MAKE CORRECTIONS
Weber Fire District
11/06/2013 11:44:42 AM

SITE GRADING AND DRAINAGE PLAN

PINEAE GREENHOUSES
NEW SITE IN OGDEN, UTAH

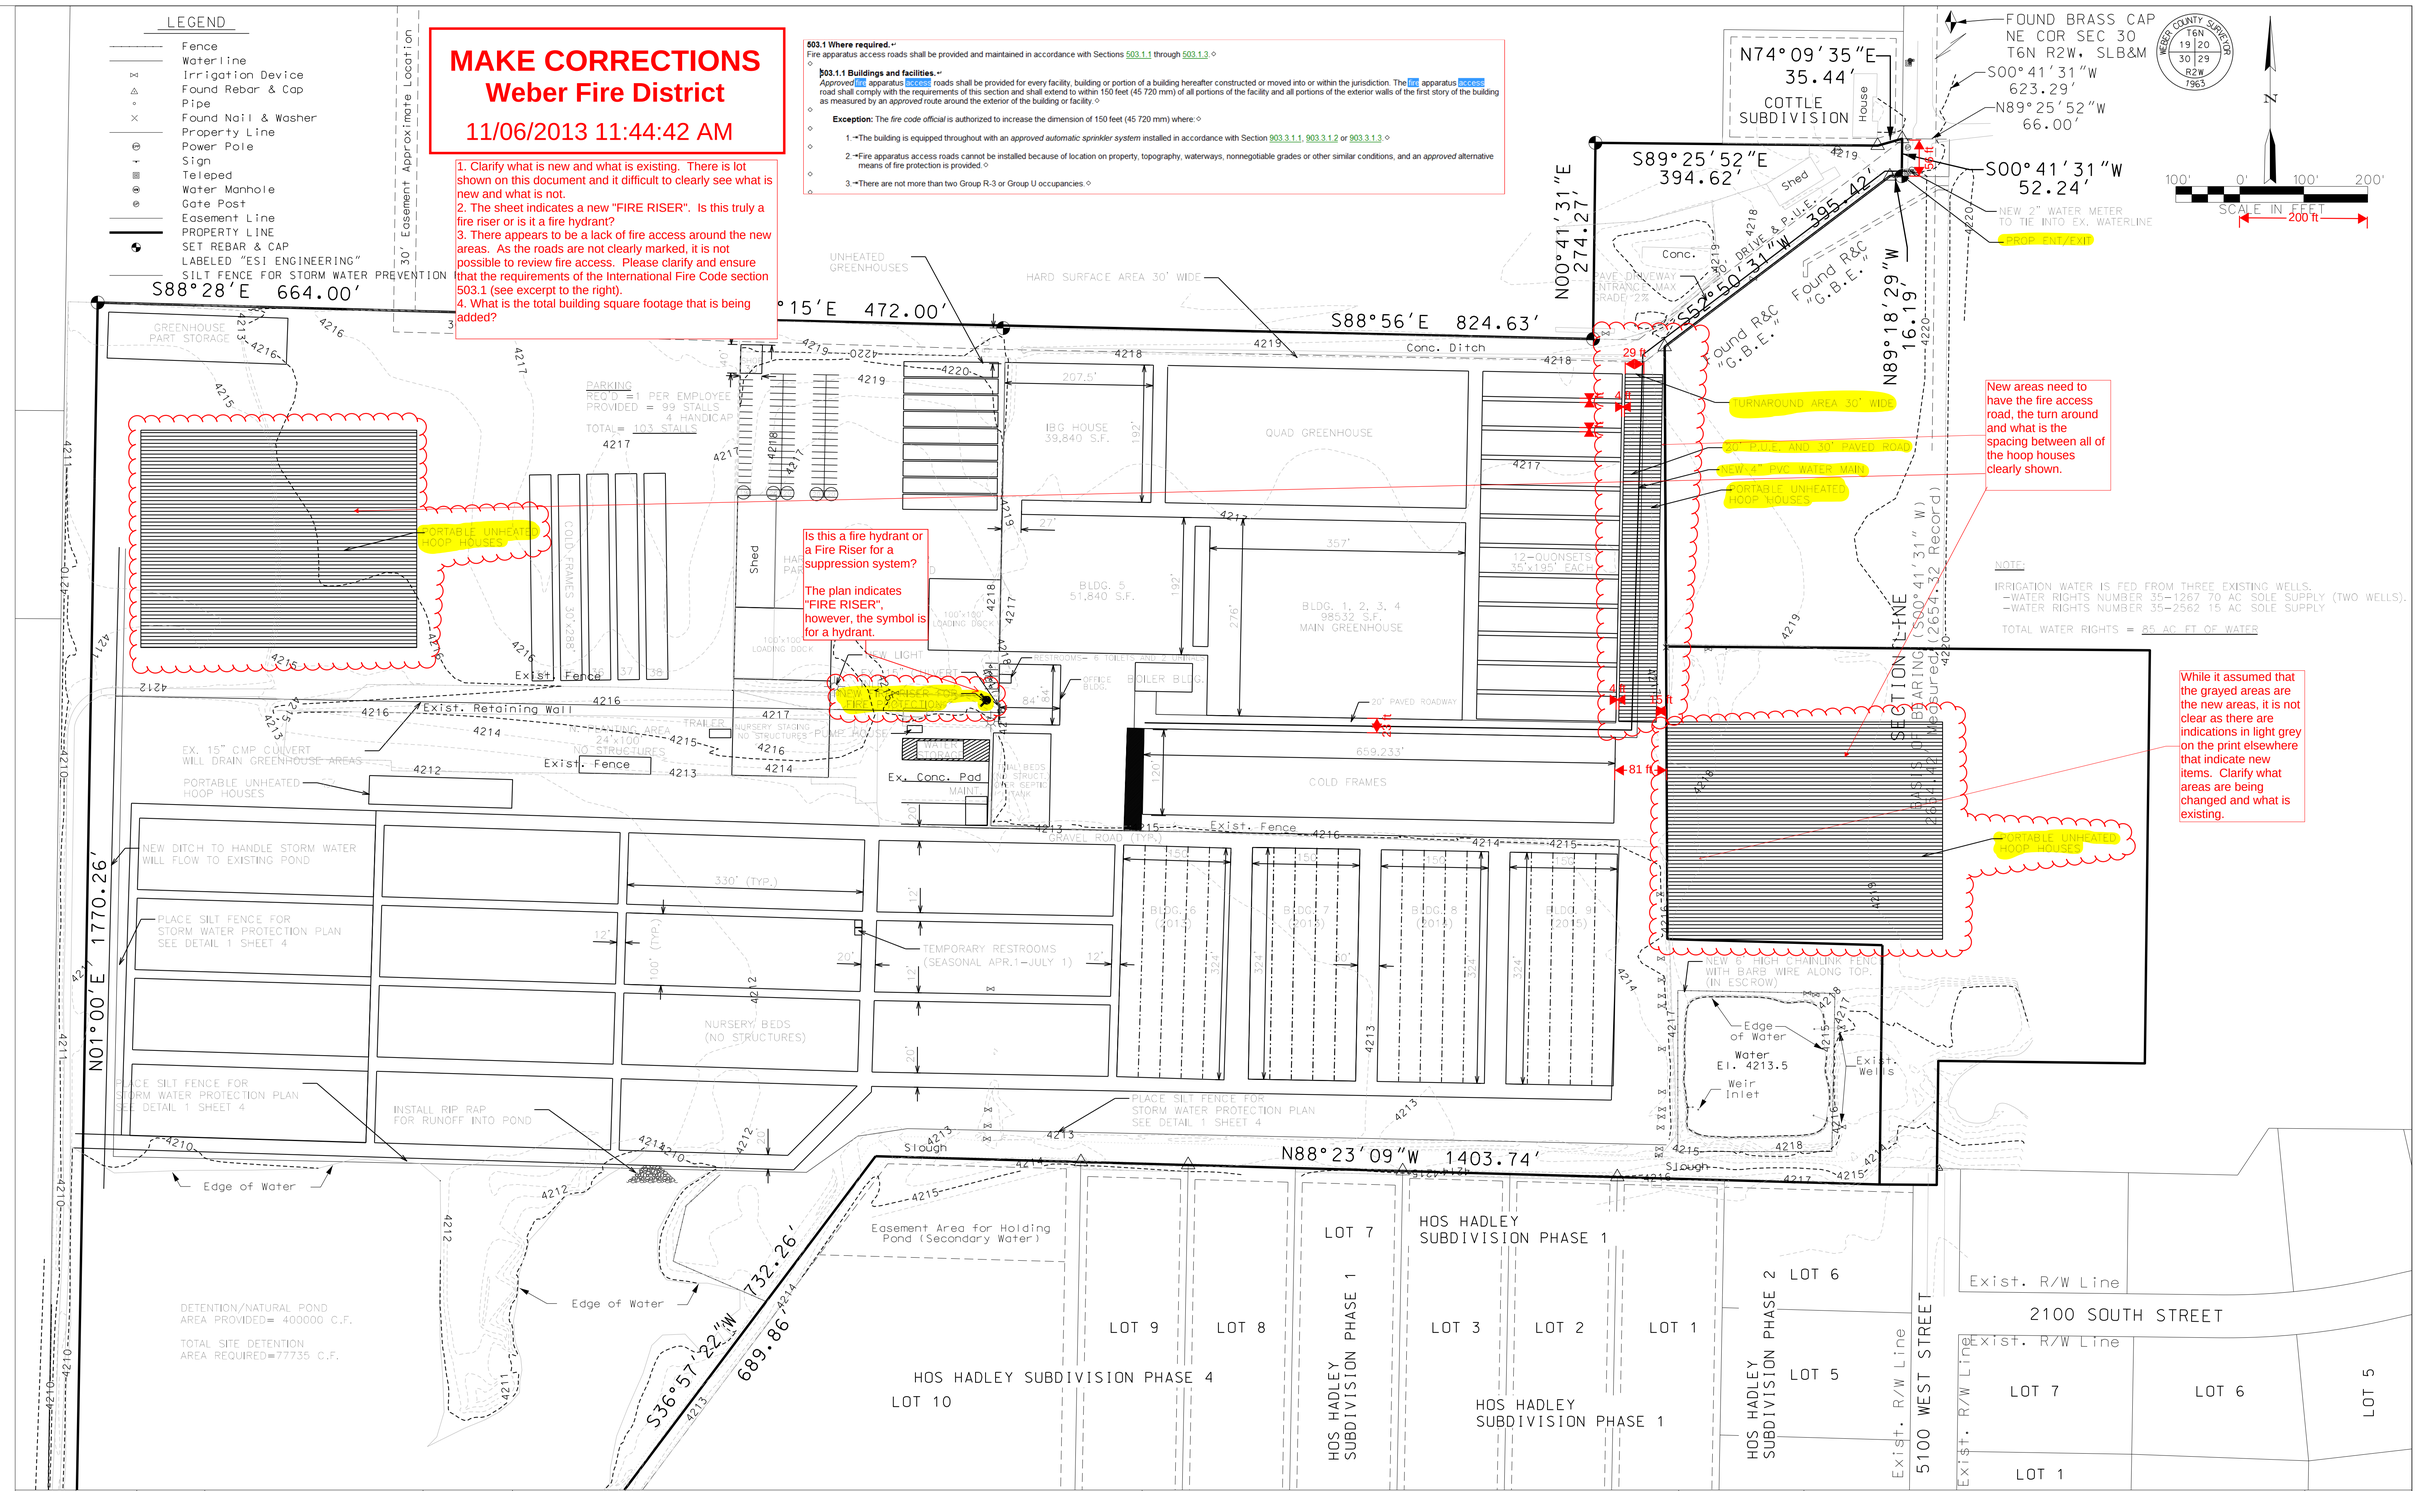
1. Clarify what is new and what is existing. There is lot shown on this document and it difficult to clearly see what is new and what is not.
2. The sheet indicates a new "FIRE RISER". Is this truly a fire riser or is it a fire hydrant?
3. There appears to be a lack of fire access around the new areas. As the roads are not clearly marked, it is not possible to review fire access. Please clarify and ensure that the requirements of the International Fire Code section 503.1 (see excerpt to the right).
4. What is the total building square footage that is being added?
